**1958 Agreement – Consideration of draft amendments
to existing Regulations submitted by GRE**

Proposal for Supplement 4 to Regulation No. 128 (LED light sources)

Submitted by the Working Party on Lighting and Light-Signalling*

Figure 1*
Main Drawing, LR3A (top) and LR3B (bottom)

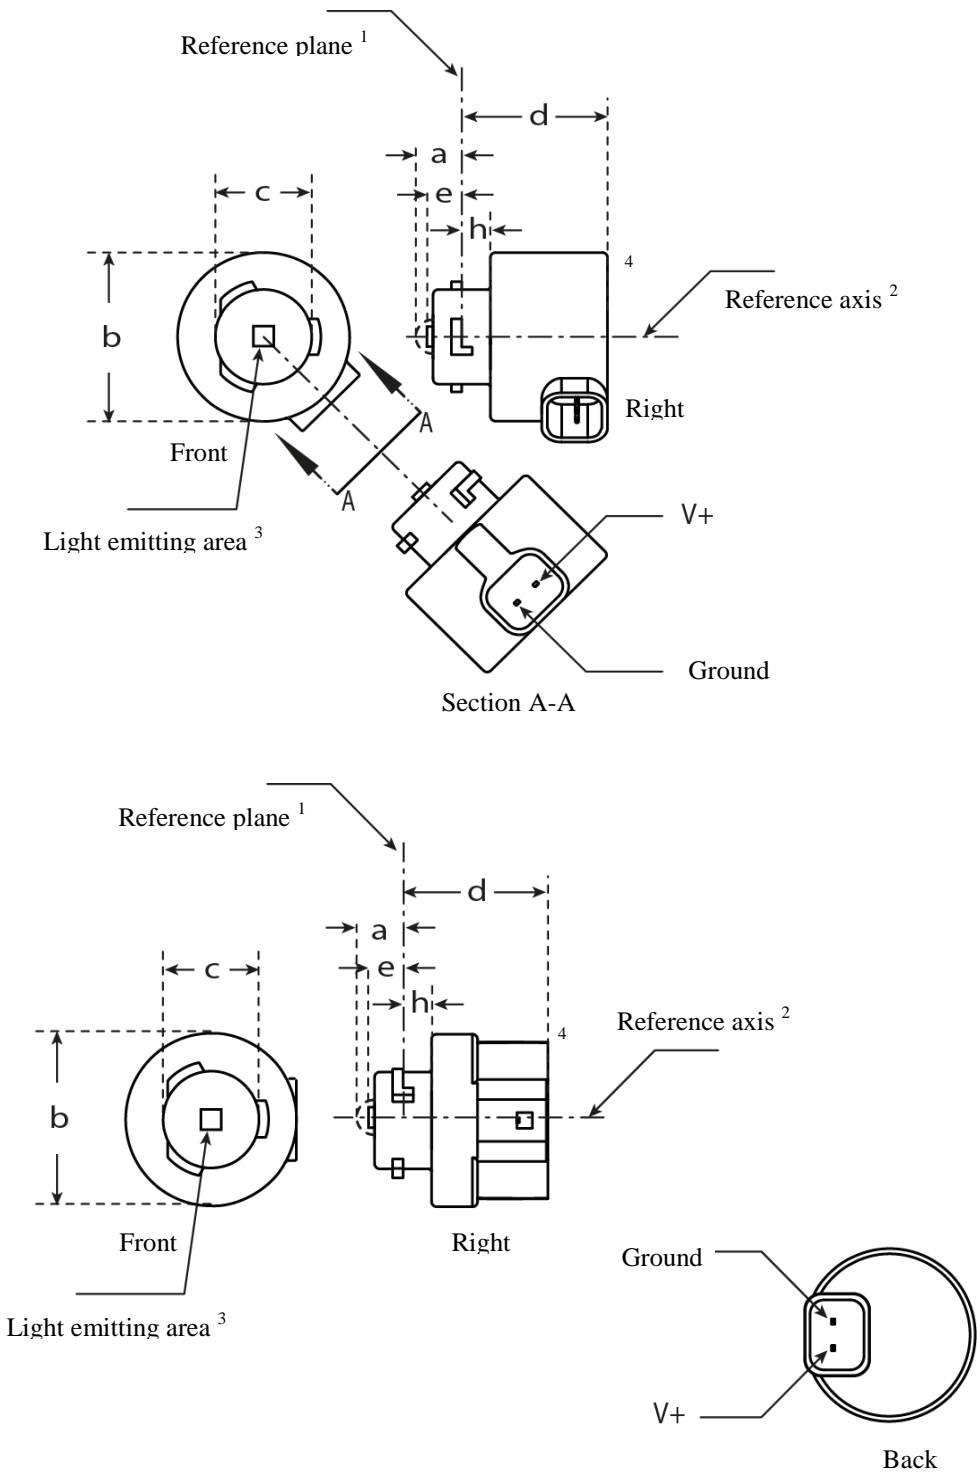
After sheet LW2/5, insert new sheets LR3/1 to 5 and LR4/1 to 5, to read (see following pages; one page per sheet):

Table 1
Essential electrical and photometric characteristics of the LED light source

| Dimensions | | Production LED light sources | Standard LED light sources |
| a | mm | 6.0 max. | |
| b | mm | c + 10.0 min. 38.0 max. | |
| c | mm | 18.5 ± 0.1 | |
| d | mm | 28.0 max. | |
| e | mm | 3.0 ± 0.30 | 3.0 ± 0.15 |
| h | mm | 5.5 + 0.0/ - 0.1 | |

Figure 2

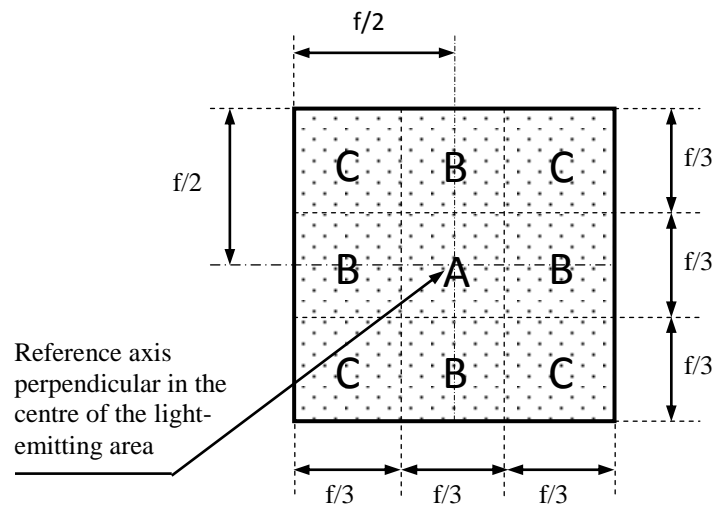
The position of the light emitting area is checked by the box system defined in Figure 2, which is aligned to the planes C90 and C180 and shows the projection when viewing along direction $\gamma=0^\circ$ (C, γ as defined in Figure 3).

Table 2
Dimensions of the box system in Figure 2

| <i>Dimensions in mm</i> | <i>f</i> |
| LED light sources of normal production | 3.0 |
| Standard LED light sources | 3.0 |

Figure 3
Set-up to measure the luminous intensity distribution, LR3A (top) and LR3B (bottom)

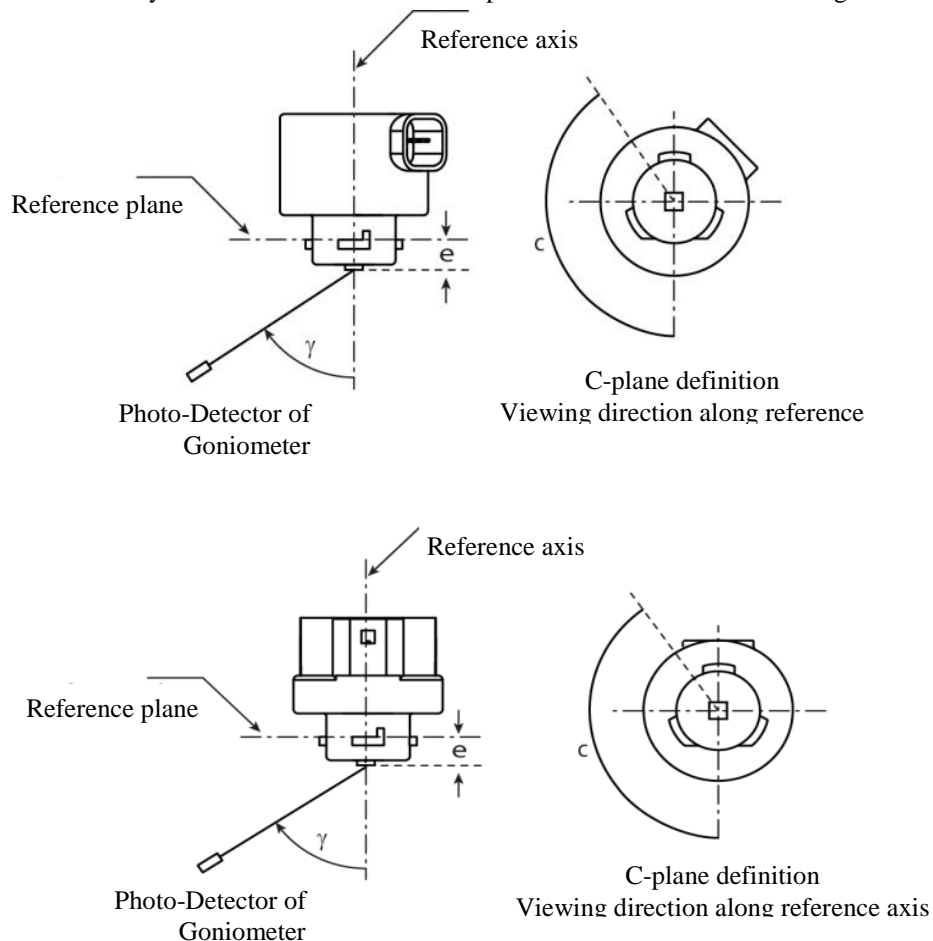
The light source is mounted on a flat plate with the corresponding mounting lug features. The plate is mounted to the goniometer table by a bracket, so that the reference axis of the light source lines up with one of the rotating axis of the goniometer. The corresponding measurement set-up is described in Figure 3.

Figure 2

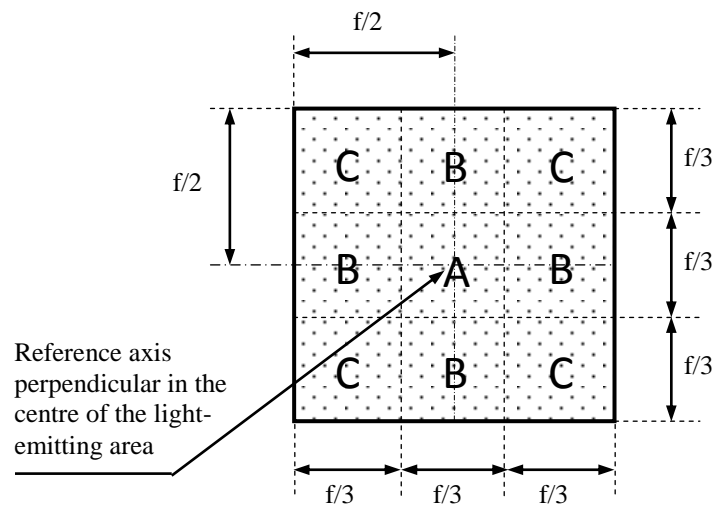
The position of the light emitting area is checked by the box system defined in Figure 2, which is aligned to the planes C90 and C180 and shows the projection when viewing along direction $\gamma=0^\circ$ (C, γ as defined in Figure 3).

Table 2

Dimensions of the box system in Figure 2

| Dimensions in mm | f |
| LED light sources of normal production | 4.5 |
| Standard LED light sources | 4.5 |

Set-up to measure the luminous intensity distribution, LR4A (top) and LR4B (bottom)

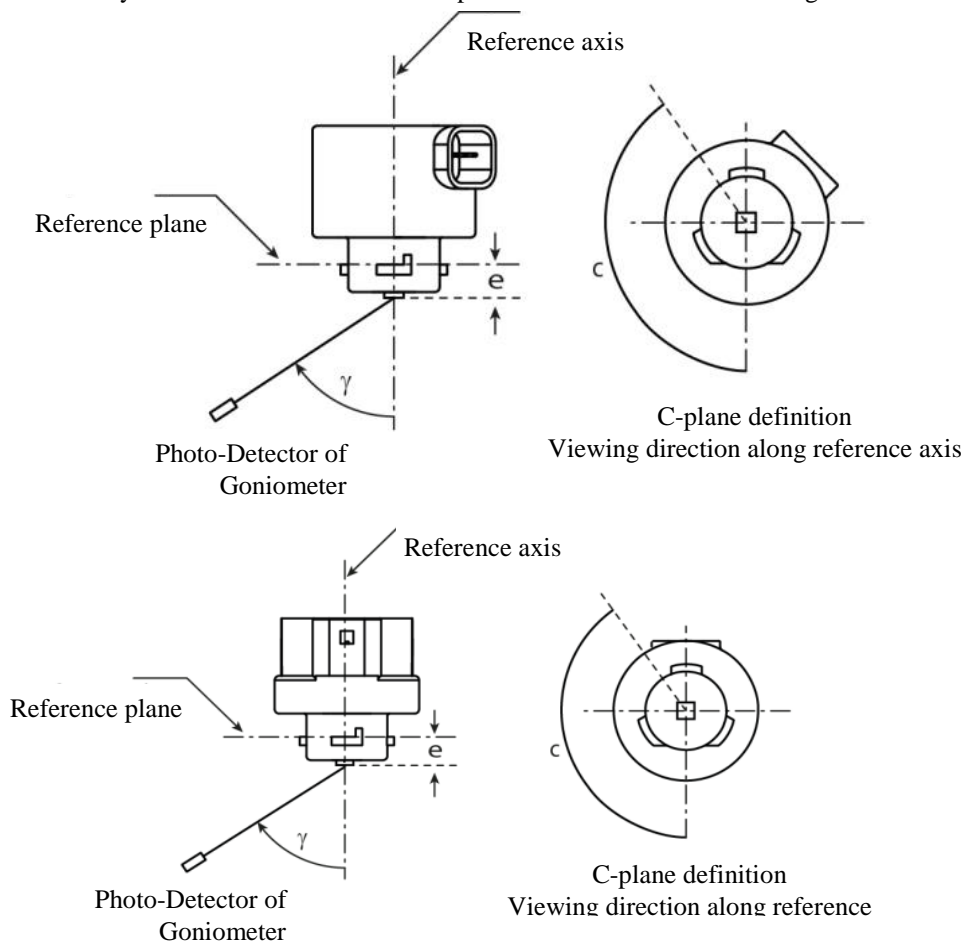
The light source is mounted on a flat plate with the corresponding mounting lug features. The plate is mounted to the goniometer table by a bracket, so that the reference axis of the light source lines up with one of the rotating axis of the goniometer. The corresponding measurement set-up is described in Figure 3.
